Applicant: Braj Agrawal: FamEP, LLC.
Consultant: Matthew Pavsek; Civil Site Group
Project: Exterior Improvements - Goddard School of Edina
Location: 7201 Washington Avenue: Edina
Rule(s): 4, 5, 11 and 12
Reviewer: BCO

General Background & Comments

C2.0

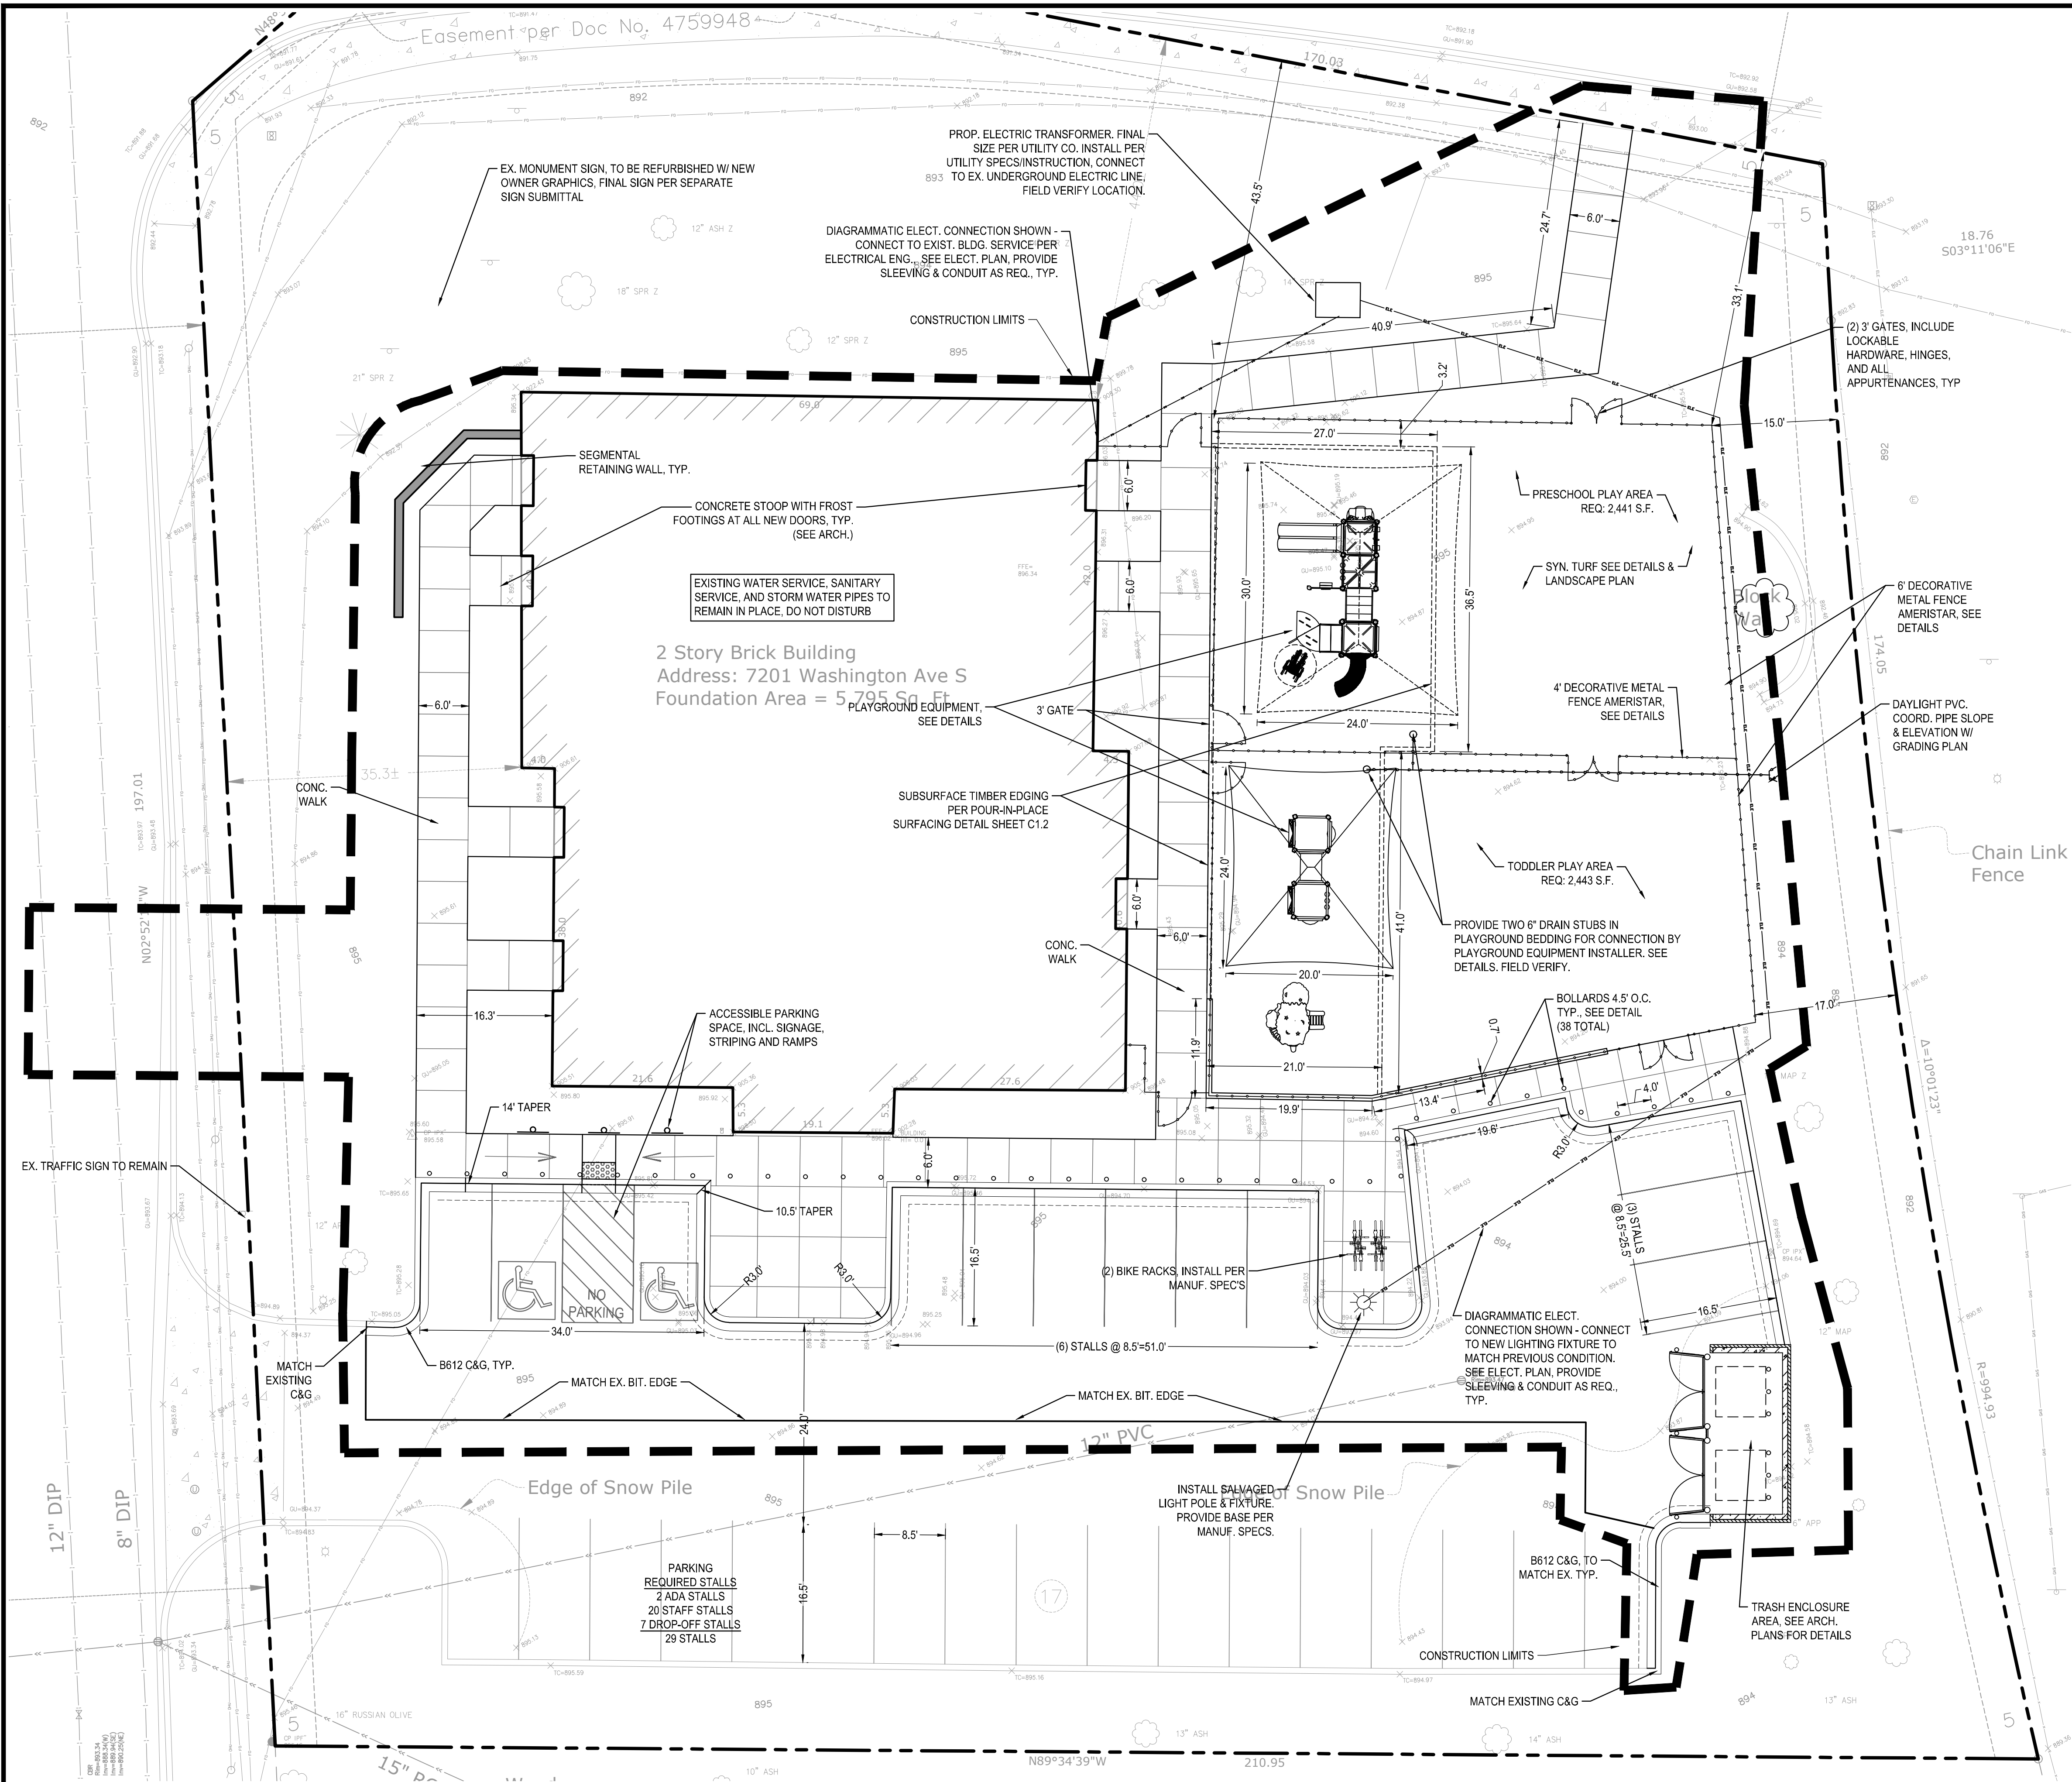
Storm water management for compliance with Rule 4.3.1 is to be provided within an underground storm water management facility (UGSWMF) to be located beneath the parking lot on the south side of the site.

A volume retention of 1,711 cubic feet is required for 1.1-inches of runoff from the 18,664 square feet of site impervious area. The UGSWMF will provide 1,766 cubic feet of volume retention. With the on-site underlying soils being classified as a sand (SP) in the area of the proposed UGSWMF, an infiltration rate of 0.8 inches/hour has been used based on the Minnesota Stormwater Manual. Using this infiltration rate, an area of 534 square feet at a maximum depth of 3.2 feet is required for the 1,711 cubic feet of volume retention to be drawn down within 48 hours. An area of 972 square feet is to be provided within the UGSWMF. Rule 4.3.1a is met.

The soil boring logs indicate that groundwater was not encountered to a depth of 20 feet, approximately elevation 872.3 M.S.L. The bottom of the proposed UGSWMF is to be elevation 887.5 M.S.L., a separation of 15.2 feet. A minimum separation of 3 feet is required between the bottom of an infiltration facility and the elevation of groundwater.

Pretreatment of storm water as required by Rule 4.3.1a (i) is not shown to be provided. Compliance will be a condition of a permit issued by the District for the project.

1. General Conditions
2. Financial Assurance in the amount of \$18,100 - \$13,100 for storm water management, erosion control and site restoration and \$5,000 for compliance with the chloride management requirements.
3. Submission of documentation that a drainage easement over the storm water-management facility has been submitted to Edina (4.5.4i), if such easements are required by the city.
4. A receipt showing recordation of a maintenance declaration for the on-site storm water management facility. A draft of the declaration must be approved by the District prior to recordation.
5. Submission of a revised plan showing pre-treatment of surface runoff prior to an infiltration facility (UGSWMF) as required by Rule 4.3.1a (i).
